GROWTH MANAGEMENT DEPARTMENT STAFF REPORT
MID-ANASTASIA DESIGN OVERLAY DISTRICT

March 10, 2022 Public Meeting
MADRB 2021-06 Anastasia Baptist Church

Summary of Request: The applicant requests design approval for demolition of the existing Educational/Administration Buildings and detached office building, and approval for construction of two new buildings to include an Education/Administration Building and a Gymnasium.

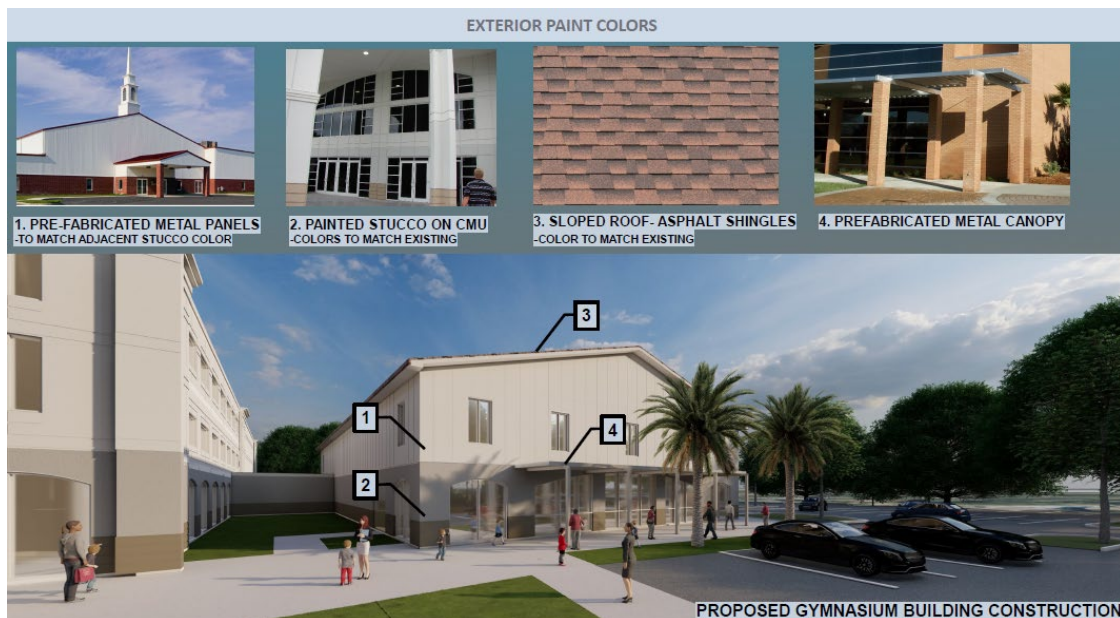
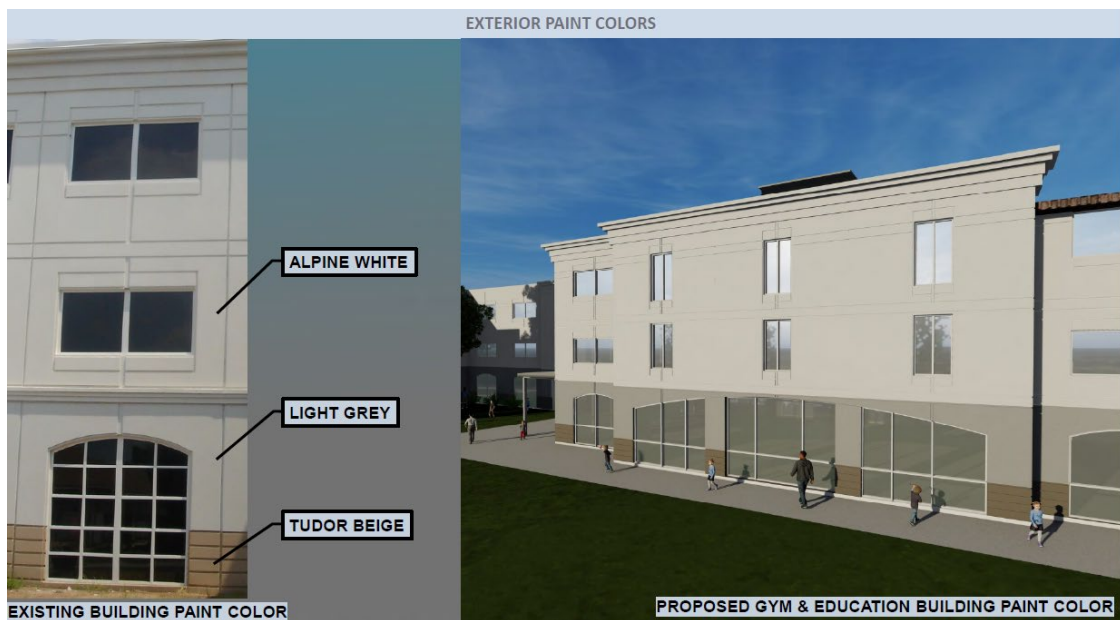
With respect to the design elements and materials proposed for the buildings, the applicant states that the proposed exterior wall coverings/colors and proposed roofing material will match the existing buildings, as previously approved. Any proposed changes to this application, as submitted, will require additional review by the Mid-Anastasia Design Review Board.

LANDSCAPE PLAN

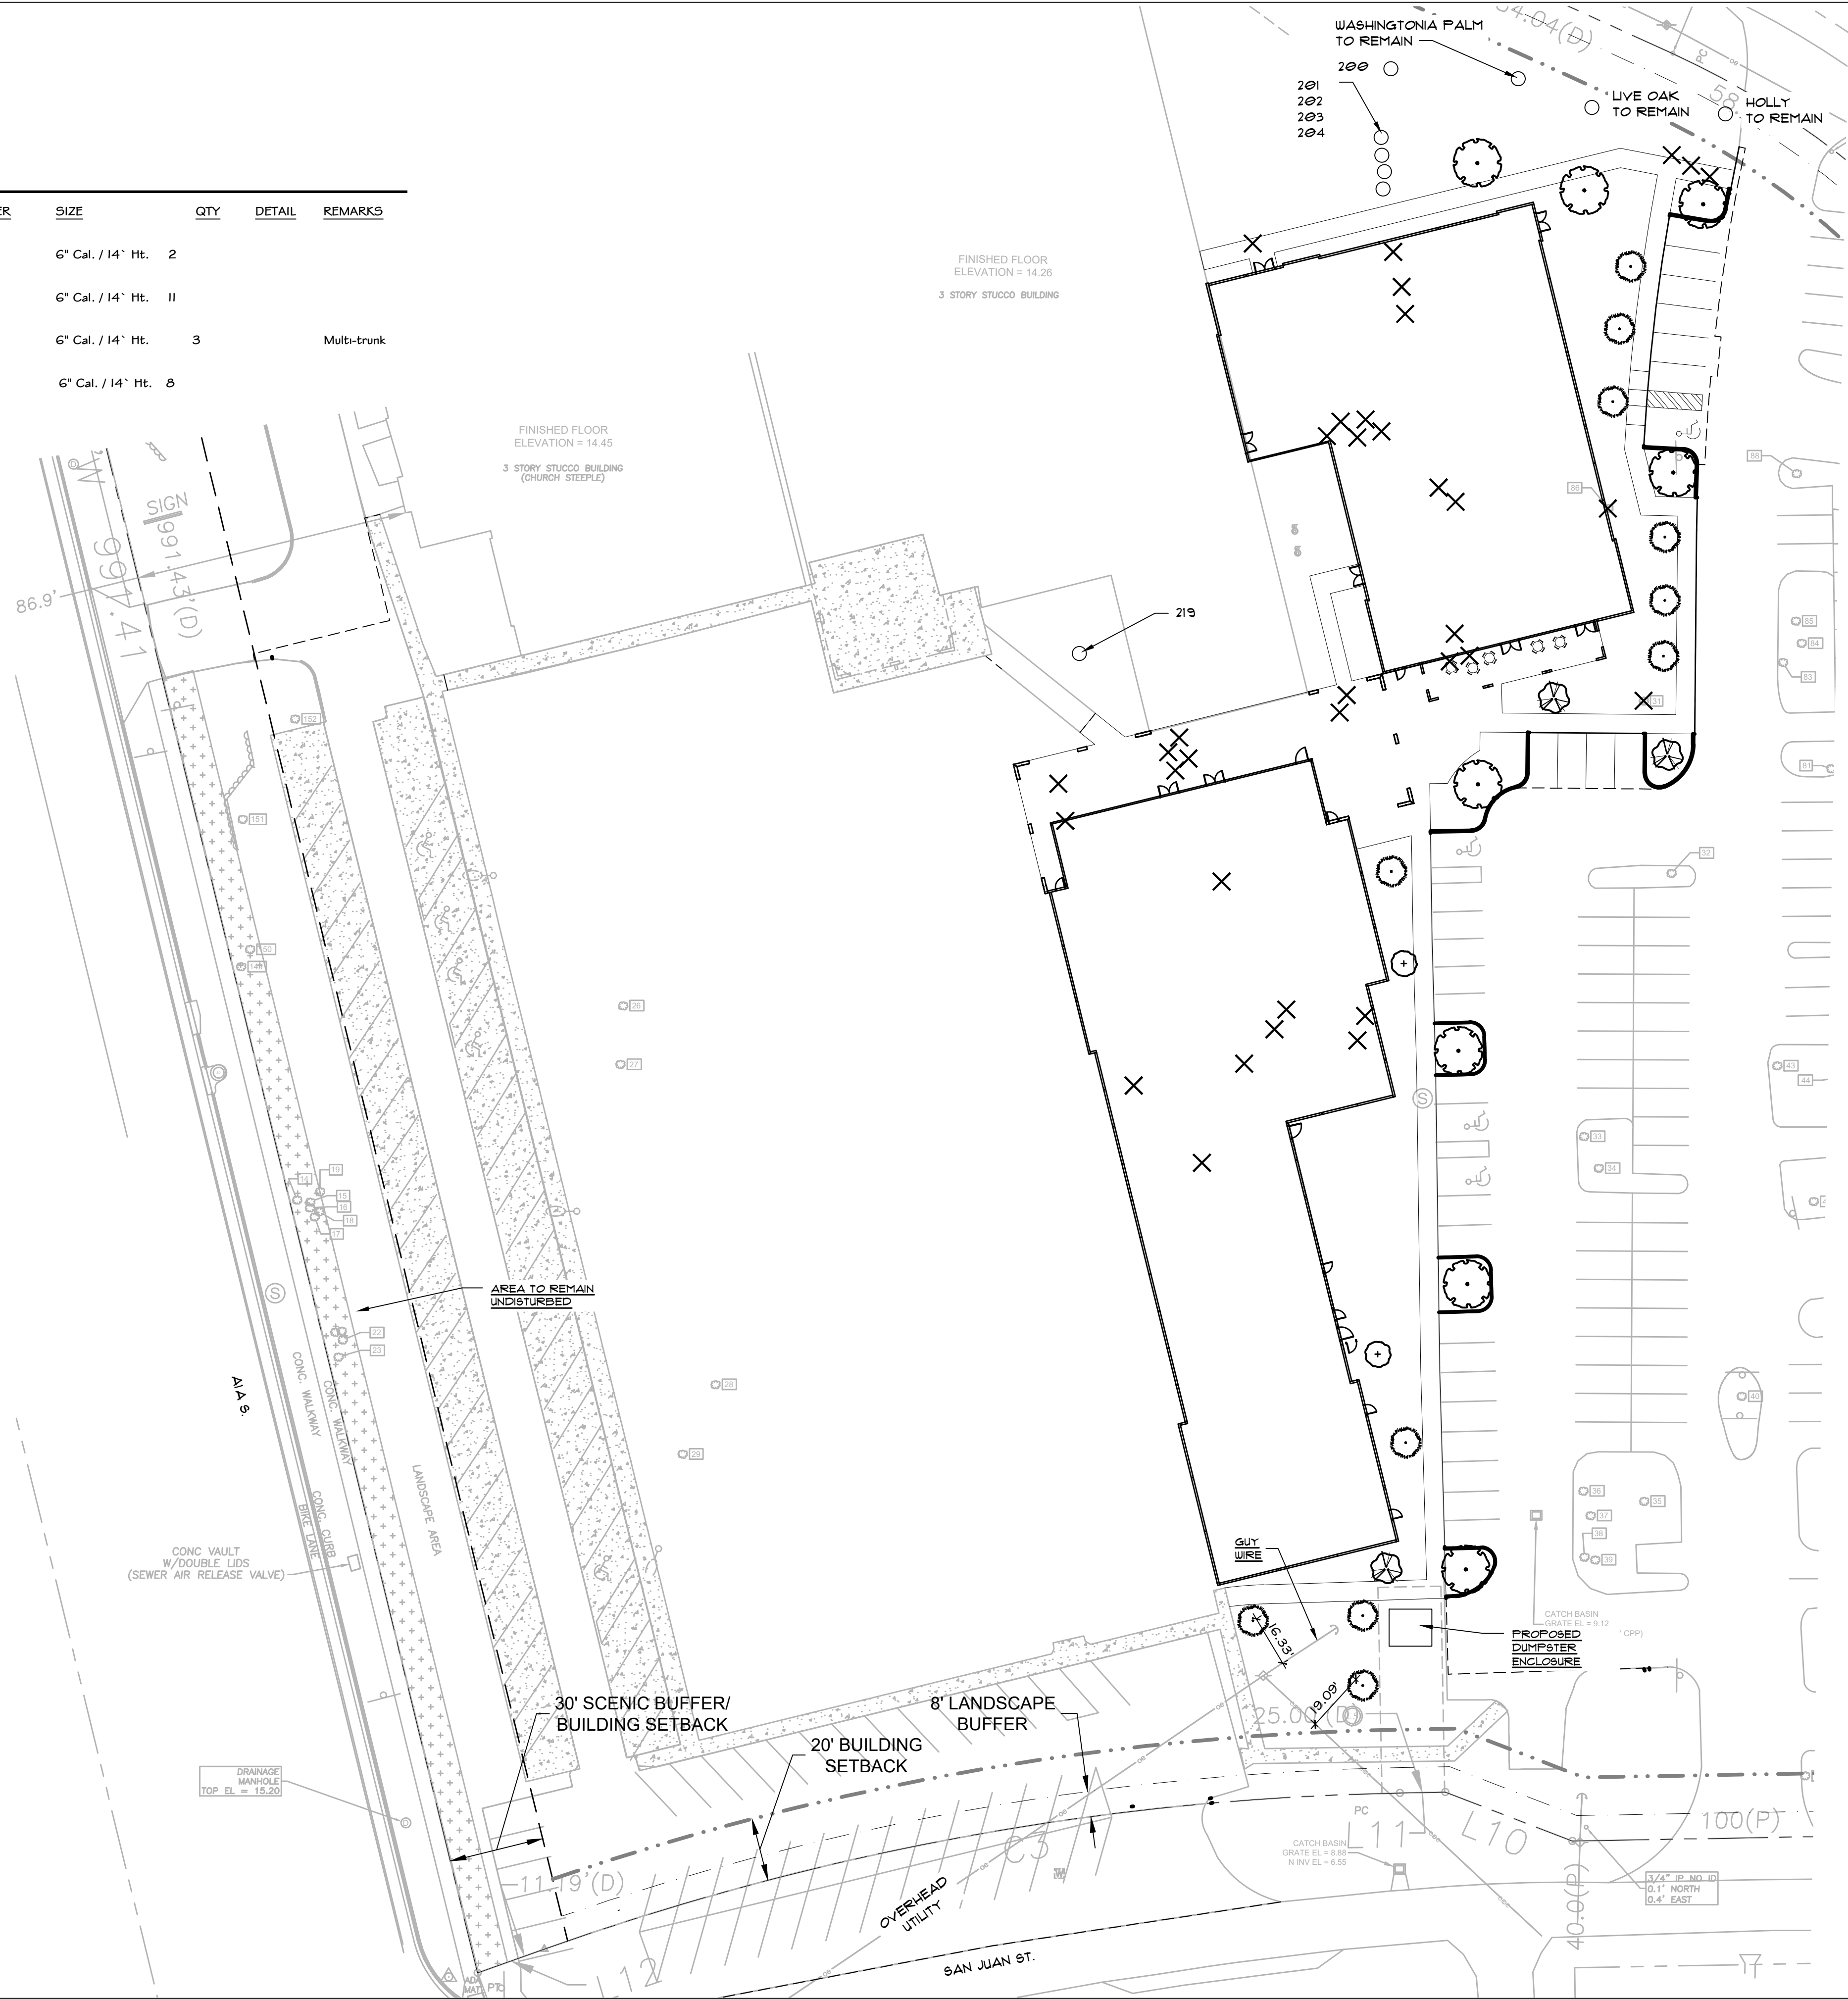
Additional buffering and screening requirements prescribed within in Section 3.08.06 are existing and are not being revised. Staff notes that a Landscaping Plan was provided as a part of this request. Section 3.08.06.A.1 allows a twenty (20) foot buffer from the right-of-way of State Road A1A South except on Scenic Highway A1A as described in 6.06.02.F.2.b. This site is on Scenic Highway A1A; therefore, according to Section 6.06.02.F.2.b, a minimum 30-foot buffer is required along A1A South. The minimum 30-foot buffer is currently provided and will not be revised as part of this proposed development. According to Section 3.08.06.A, a minimum 15-foot buffer is required along Old Beach Road and this buffer is not being provided. The current buffer is 8 feet and is not being revised or disturbed, and this area of the site and buffer along Old Beach Road does not appear as being proposed for revision.
